Title - Sujet Intervention Building - La Macaza	
Solicitation No. - N° de l'invitation EF236-133529/A	Amendment No. - N° modif. 002
Client Reference No. - N° de référence du client R.042764.001	Date 2013-05-08
GETS Reference No. - N° de référence de SEAG PW-\$MTC-250-12299	
File No. - N° de dossier MTC-2-35366 (250)	CCC No./N° CCC - FMS No./N° VME
Solicitation Closes - L'invitation prend fin at - à 02:00 PM on - le 2013-05-23	
F.O.B. - F.A.B. Plant-Usine: <input type="checkbox"/> Destination: <input checked="" type="checkbox"/> Other-Autre: <input type="checkbox"/>	
Address Enquiries to: - Adresser toutes questions à: Cyr, Nicolas	Buyer Id - Id de l'acheteur mtc250
Telephone No. - N° de téléphone (514) 496-3389 ()	FAX No. - N° de FAX (514) 496-3822
Destination - of Goods, Services, and Construction: Destination - des biens, services et construction: 321 chemin de l'Aéroport La Macaza (QC) J0T 1R0

Le présent addenda fait partie intégrante des documents de soumission et a pour objet de modifier et clarifier les plans et devis du projet précité. Les modifications décrites ci-après entrent en vigueur immédiatement.

ADDENDUM PAGEAU MOREL NO. 1

PANNEAU NO: BP-25D1

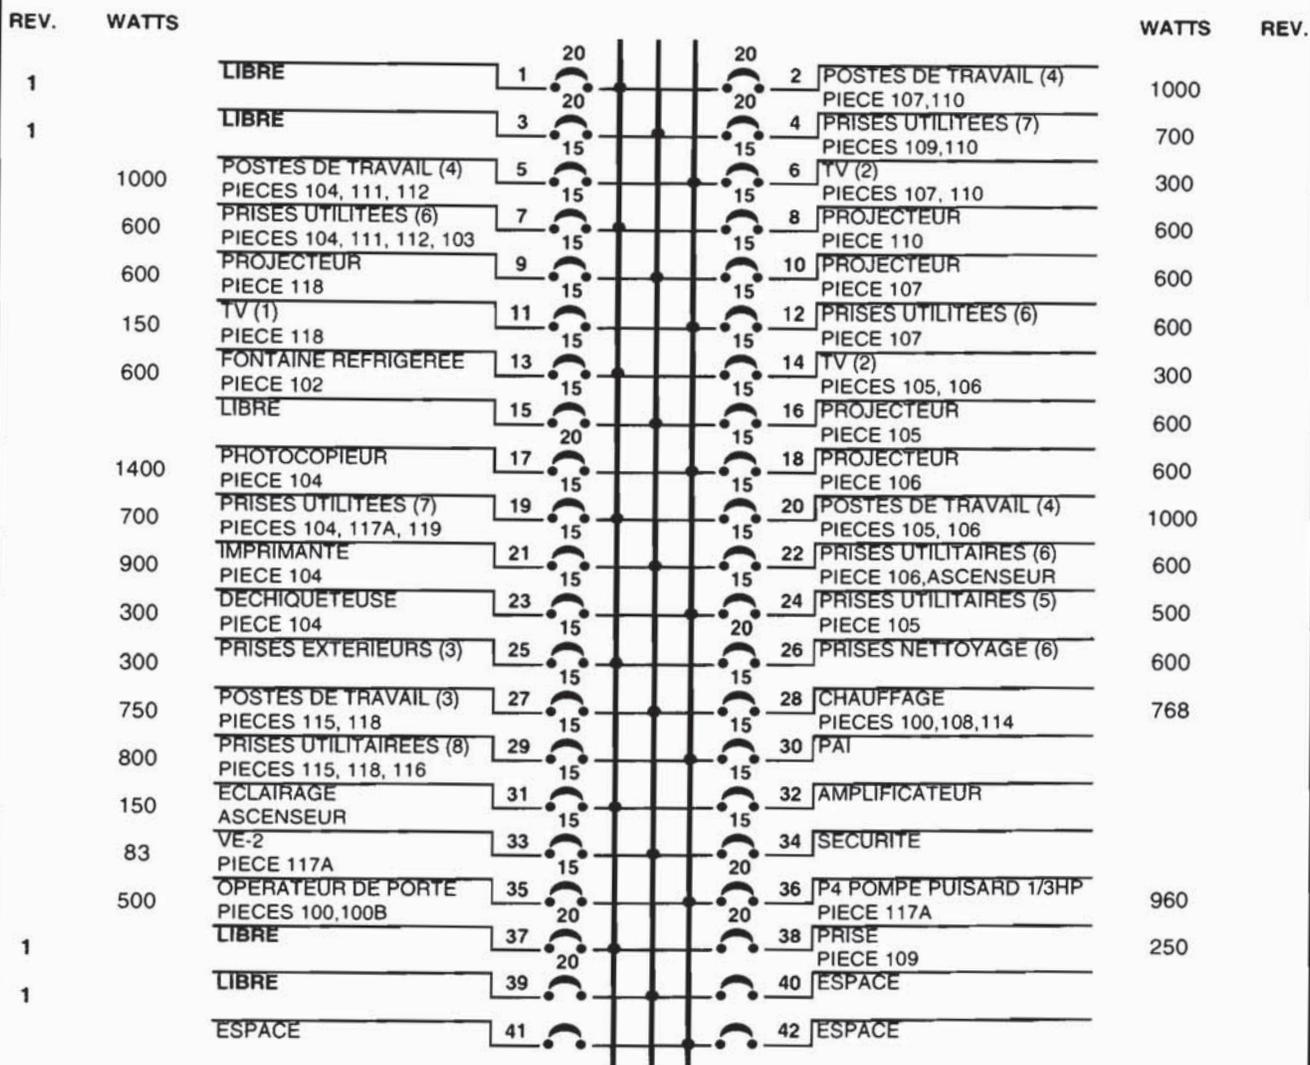
- .7 The appendix « Photos of the existing installation » is transmitted with this addendum.
- 4.1.2 Section 26 24 16.01 « Panelboards Breaker Type »
 - .1 The appendix of the section is revised as per panels list transmitted with this addendum.
